## Strip lifter with disc

Produktänderung\*  
Product modification  
Modification des produits

D 3002A 03.2023

Z4902-L-L1

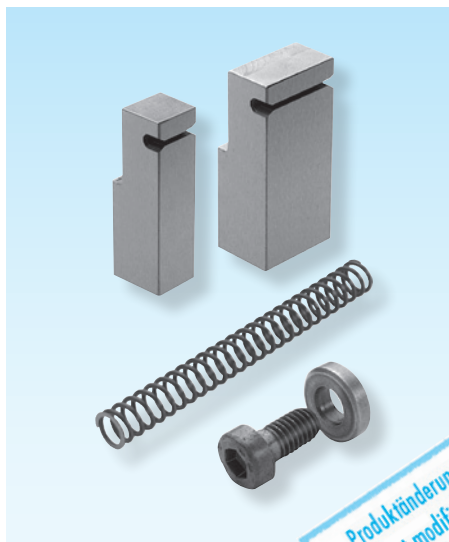
\*Auslaufend! Abverkauf bis 31.12.2023.  
Discontinued! Sales until 31.12.2023.  
Discontinu  ! Ventes jusqu'au 31.12.2023.

Z4920-L-B1-H

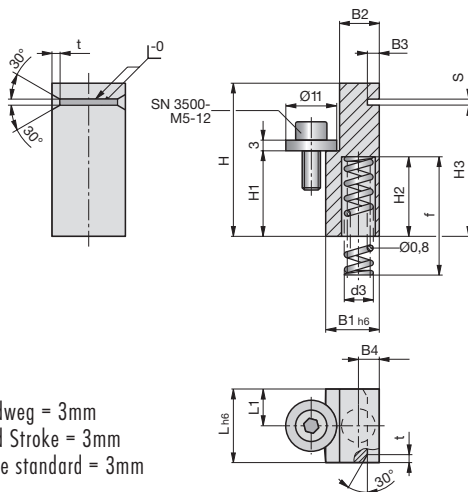
Produkt nderung\*  
Product modification  
Modification des produits

\*Auslaufend! Abverkauf bis 31.12.2023.  
Discontinued! Sales until 31.12.2023.  
Discontinu  ! Ventes jusqu'au 31.12.2023.
